AIRWORTHINESS DIRECTIVE

No. 2024-AHCAT, AHCAT-CK-09

Applicability – ANSAT helicopters (ANSAT, ANSAT-GC models)
Designer's State - RUSSIAN FEDERATION

TECHNICAL DECISION No. 1/144-2024-KB3
on continued airworthiness of the ANSAT helicopters (ANSAT, ANSAT-GC models)

Figure 201 – Visual inspection of XP-23 tail gearbox casing and cover

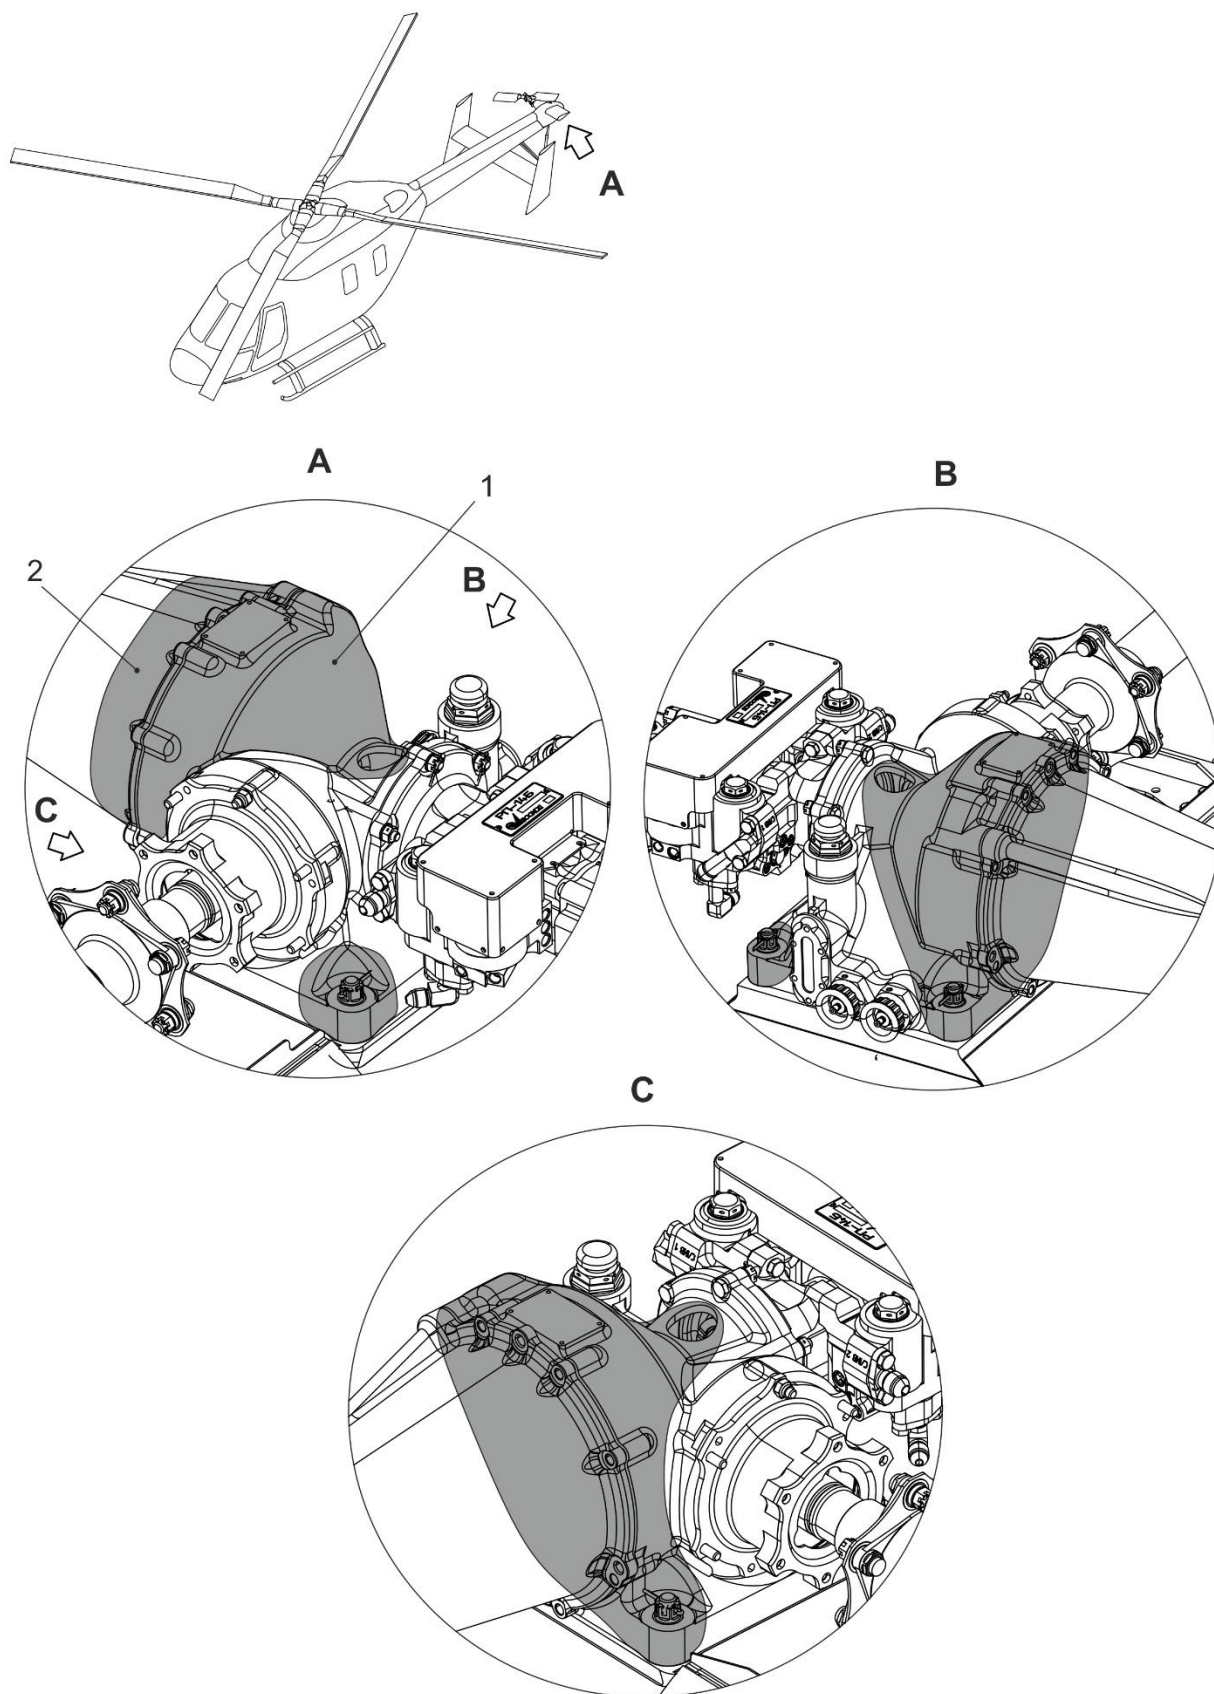
Temporary task card 065.20.00k		
Procedure: Visual inspection of XP-23 tail gearbox casing and cover		
Operations and technical requirements		Corrective actions
1 Remove the tail rotor (see TC No. 064.20.00c). 2 Install the tail rotor on the trestle. 3 Remove the left and right fairings of the tail gearbox. 4 Clean the tail gearbox casing. 5 Inspect the tail gearbox casing (1) joint with cover (2), as well as casing (1) joints with the tail boom (indicated by the color in figure 201). Presence of cracks, nicks and corrosion damages on the surfaces of the parts is not allowed. 6 Install the left and right fairings of the tail gearbox. 7 Install the tail rotor (see TC No. 064.20.00d).		If any defects are detected, take photographs of them and send together with the inspection report to JSC “Kazan Helicopters” to make a decision on the possibility of further operation.
Test equipment	Tools and appliances	Expendable materials

Figure 203 – Tail rotor blade

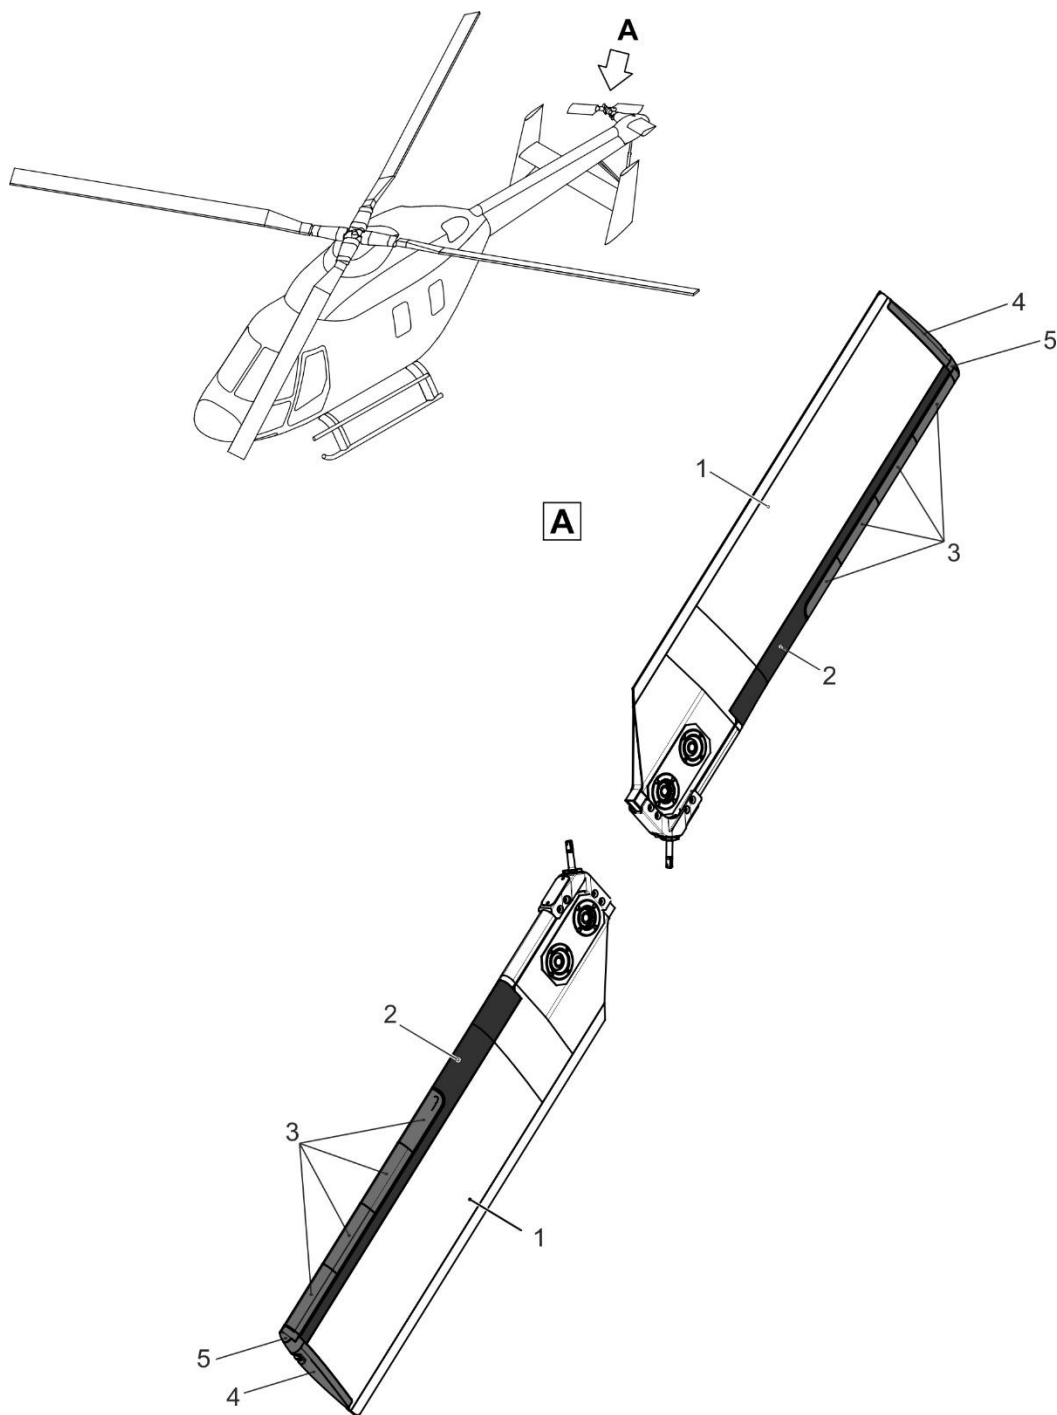
1. Remove the tail rotor (see TC No. 064.20.00c). 2. Perform visual inspection of tail rotor blades (see TC No. 064.10.00c). 3. Perform a visual inspection of the condition of the rubber layer of strips (2) (see figure 203) of the tail rotor blades (1) for absence of damages. Crumbling of the rubber layer with a total area of no more than 10 cm² with the size of a single crumbling with an area of no more than 2.5 cm² and a width of no more than 0.5 cm is allowed. 4. Perform visual inspection of condition of tips (4) and blade edge tippings (5) of tail rotor blades (1). Pay special attention to the blade edge tipping (5) fastening screws on the blade tip (4). 5. Check the absence of non-glueing of rubber layer of the strips (2) and blade edge tippings (3), as well as glue joint of tips (4) and blade edge tippings (5) of tail rotor blades (1) by tapping with a duralumin hammer, proceeding as follows: tap the entire rubber area of the strips (2) and blade edge tippings (3), as well as tips (4) and blade edge tippings (5) with a free fall of the duralumin hammer from a height of no more than 10 ... 15 mm or with soft blows from a distance of no more than 10 mm, avoiding traces of tapping. Violation of glueing is characterized by a change in tone. The presence of non-glueing is not allowed. 6. Install the tail rotor (see TC No. 064.20.00d).		If any defects are detected during the inspection according to pp. 2 - 5, fill in the chart of tail rotor blades inspection (see figure 202), take photos of the defects. Make marks on the tail rotor blades with a soft pencil.
